Adq Preliminary SL25 trapper Mine

Re: Trapper Mine Inc; Permit C1981010
DRMS Preliminary Adequacy Review of Bond Release Request SL25

Map1 sheets 1 and 2

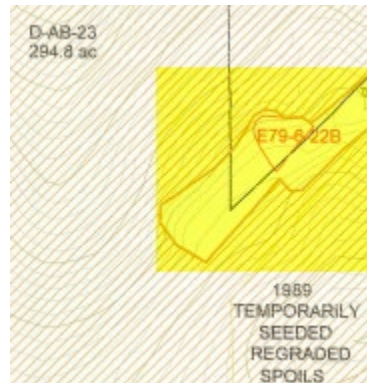
1. *Acres for parcel DAB23 is listed as 284.9 acres in the text portion of the submission and as 294.8 acres on Map 1. Please clarify the acreage and submit any revised pages or maps as required reflecting the correct acreage.*

2. *Please depict this parcel on the applicable map and provide as a revised map.*
3. *The following illustration highlights a parcel that is unidentifiable to DRMS as it lands on the seam between the two map sheets. Please clarify the parcel nomenclature on Map sheet 1 and associated acres with a revised map, possibly utilizing a call out block for visibility.*
